Consumers Power Company
Palisades Plant
Docket 50-255

BENCH-MARKING OF THE MHACALC CODE
EA-PAH-91-05

EA-PAH-91-05

Title BENCHMARKING OF THE MHACALC CODE

FIGURE 1
CONTAINMENT RELEASE PATH MODEL

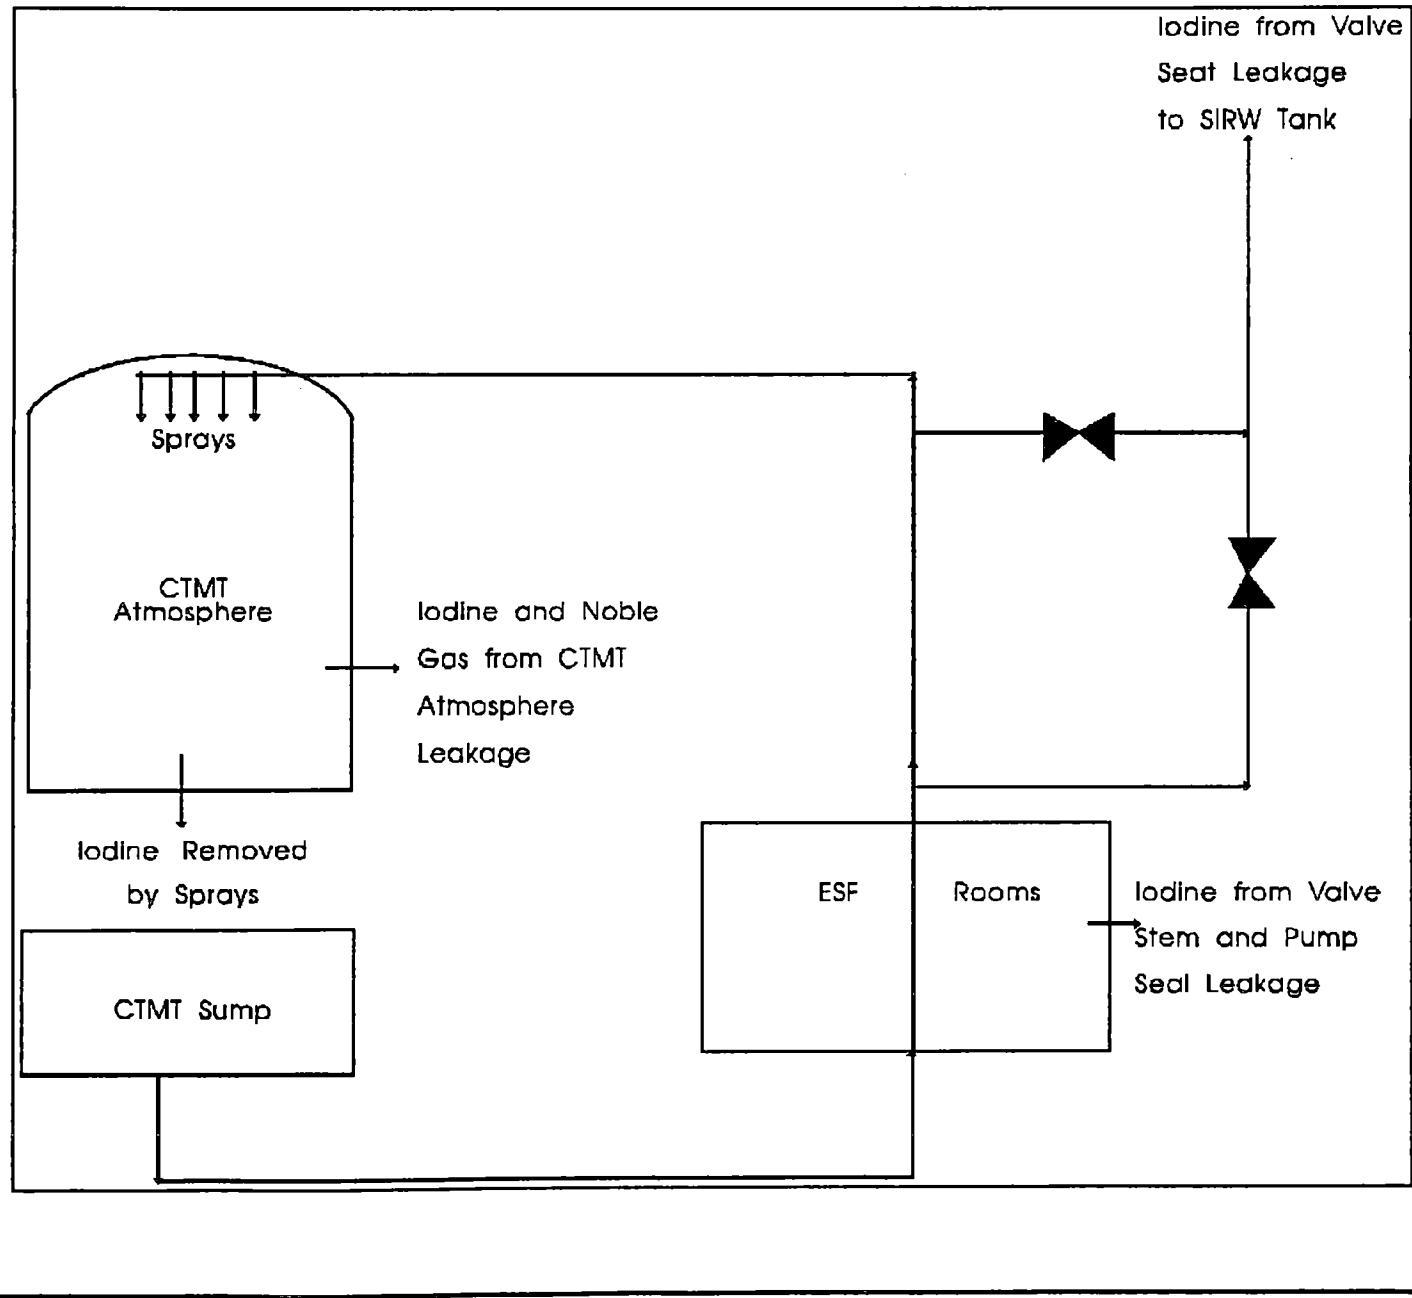
4	Figure 1	It might be helpful to add a couple of arrows to indicate radionuclide addition to chut & chut sump. See marked up copy. Also, larger arrowheads would be nice. The existing ones can barely be seen.				④ Since the source term release is assumed to be instantaneous, as opposed to a continuous release over a period of time,		
5	Section 6.1.1	Reviewed in first version of this EA . No changes have been made to the writeup	significant			I chose not to revise the figure.		
6	Section 6.1.2	Reviewed in first version of this EA . No significant changes have been made to the writeup				⑤ No response required.		
Reviewer		Organization	NEFCO/RISA/SIA	Date	19 Feb 92	Review Coordinator	Date	3/2/92
Stacy D. Winter							Document Sponsor	Revised
							Date	3/2/92
